4.4.5 Extending the Temperature Range of Electric Submersible Pumps to 338 °C - Hotline IV - High-temperature ESP

Presentation Number: 019

Investigator: Dhruva, Brindesh (Schlumberger Technology Corp.)

Figure 26: Extending the Temperature Range of Electric Submersible Pumps to 338 °C - Hotline IV - High-temperature ESP

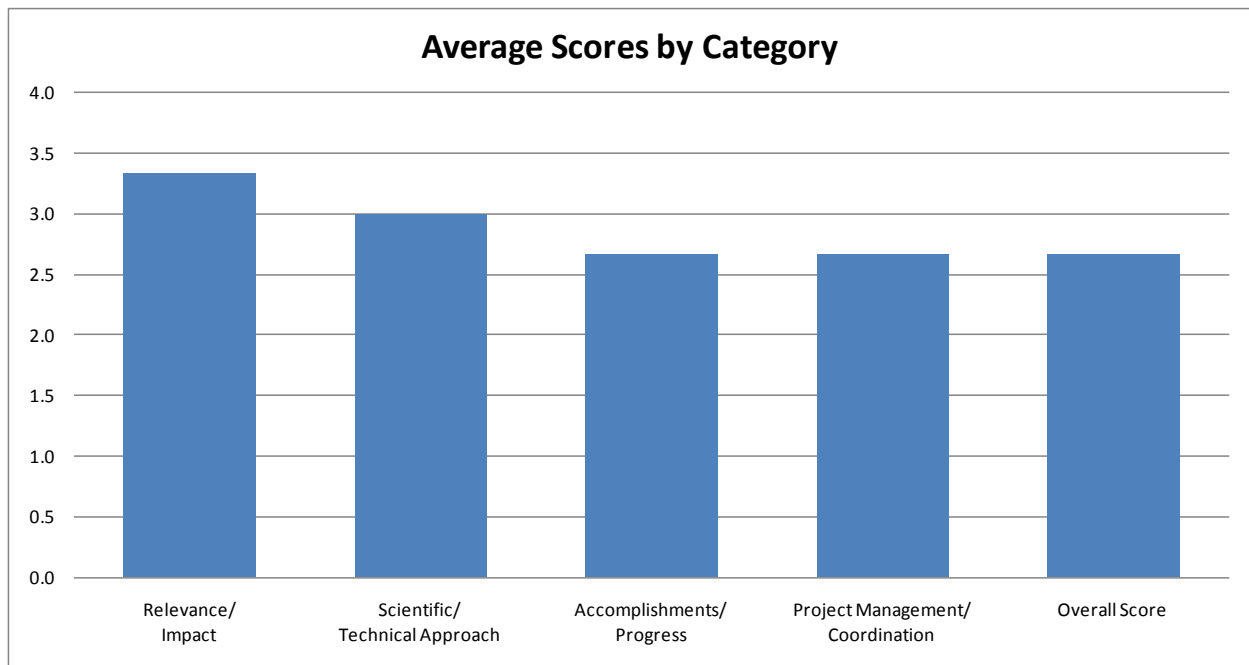
- Progress has suffered a number of setbacks, some of which were probably beyond the control of the project managers, but the project is definitely behind schedule.
- The comparative data used in the presentation might not be isolated enough to be useful. For example a 1500 HP motor and a 320 HP motor were displayed operating at temperatures of

218/288 °C and 150/205 °C, respectively. The first temperature was the brine temperature and the second temperature was the motor temperature. Since the motor temperatures were not measured it's not clear how the second temperature was obtained. This data needs to be validated. One pump has been tested to 260 °C. They still have a ways to go.
